Intel[®] Mobile Celeron[™] Processor at 466 MHz, 433 MHz, 400 MHz, 366 MHz, 333 MHz, 300 MHz, and 266 MHz Specification Update

Release Date: February 2000

Order Number: 244444-012

Figure 2. Workaround Flowchart: SMBALERT#-Driven System

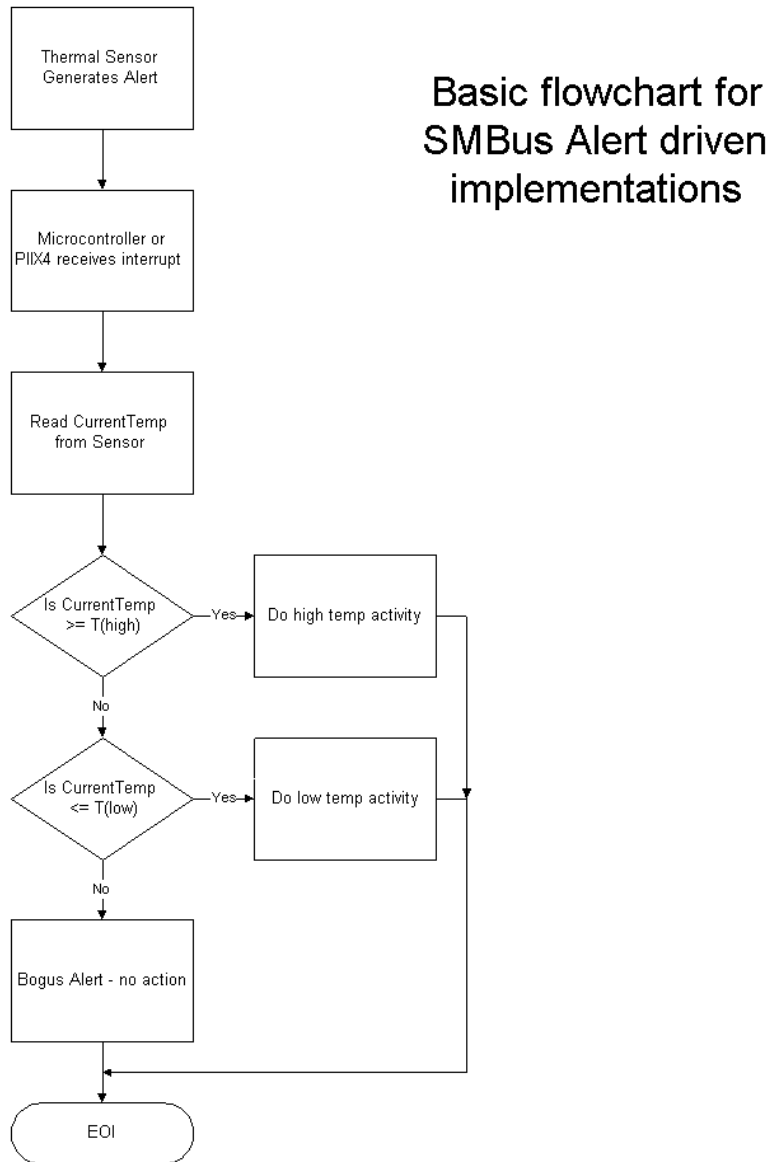
H29. Thermal Sensor May Assert SMBALERT# Incorrectly

Problem: The Intel Celeron Processor Mobile Module has a thermal sensor that monitors the processor core's temperature. Please note that desktop systems could have a similar thermal device. The thermal sensor asserts SMBALERT# if the processor temperature exceeds the temperature limits set in the Alarm Threshold Registers (T_{HIGH}, T_{LOW}). It also sets the corresponding Status Register bits to identify the cause of the interrupt. Figure 1 gives one example of the how the SMBALERT# signal could be used in a system.

Workaround: Three different (mutually exclusive) workarounds are possible:

1. Before servicing an interrupt from the thermal sensor, read and compare the processor thermal reading with the threshold limits (T_{HIGH} or T_{LOW}). Figures 2 and 3 provide basic flowcharts for the implementation of this workaround in an interrupt driven system.
2. If the firmware implemented polls the Status Register only, then before taking any action, re-read the temperature register and do a comparison with the alarm threshold limits (T_{HIGH} or T_{LOW}) to determine if the value is actually still within the temperature window.
3. Use a temperature polling scheme to monitor the processor temperature.

Figure 5.3. Surface-Mount BGA1 Package—Top and Side View

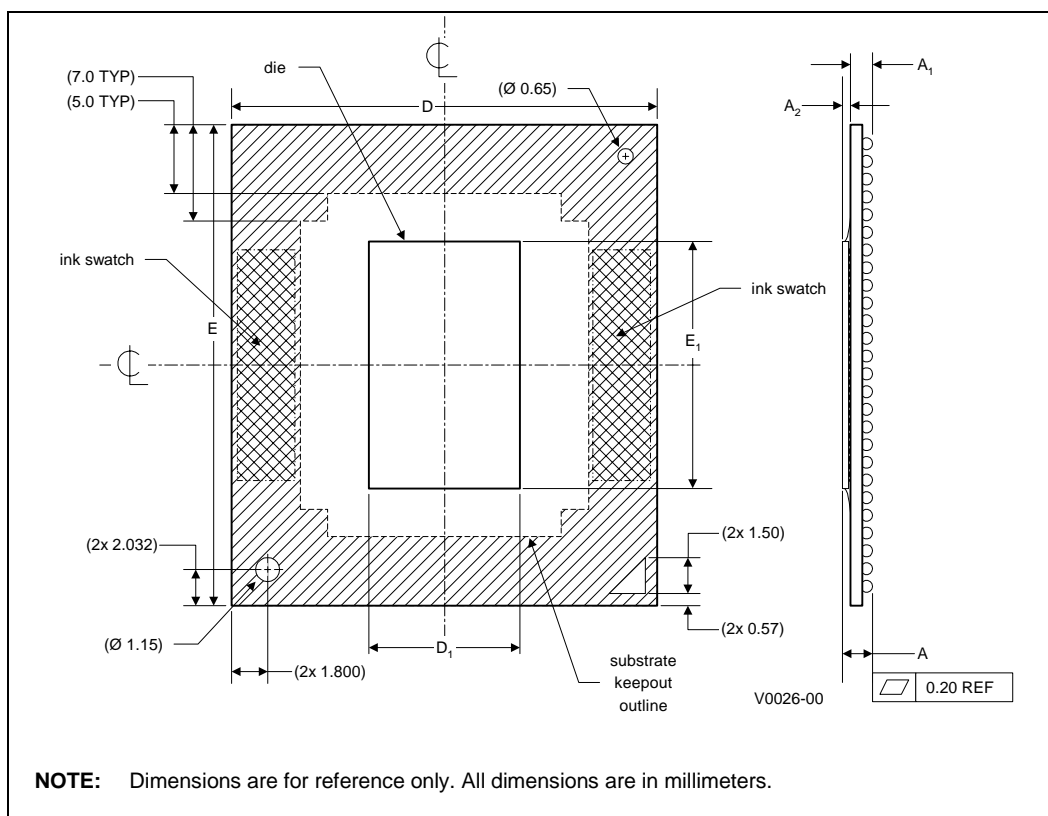
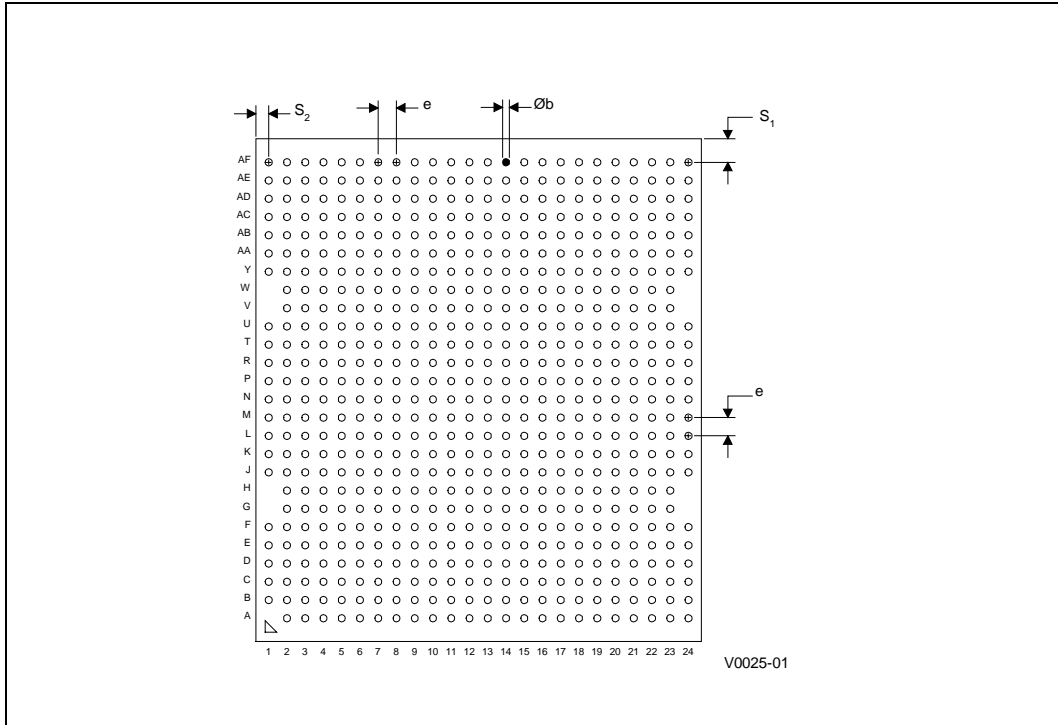
The following table and figures show the updated mechanical specifications for the BGA1 package, listed as Table 5.2, Figure 5.3 and 5.4, respectively, in the *Intel® Mobile Celeron™ Processor in BGA Package at 333 MHz, 300 MHz and 266 MHz* datasheet.

1. The number shown here is different from that in the 244444-004 version of this specification update. The maximum reference number is used.

Figure 3.3 Generic Clock Waveform

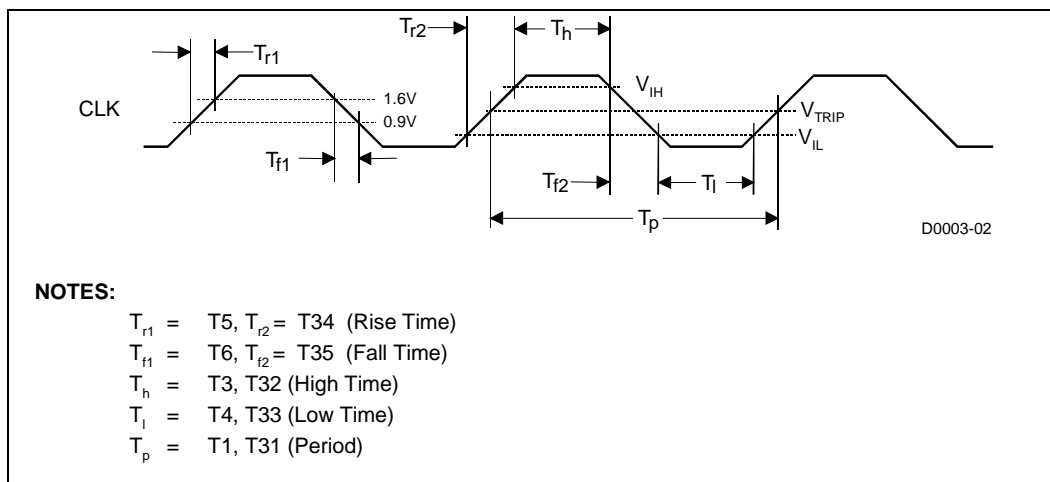
H11. Generic Clock Waveform Figure

Figure 3.3 in the *Intel® Mobile Celeron™ Processor in μ PGA1 and BGA1 Packages at 366 MHz, 333 MHz, 300 MHz, and 266 MHz* datasheet (Order Number 245112-003) has been updated. The following figure is to replace the one in the above document.
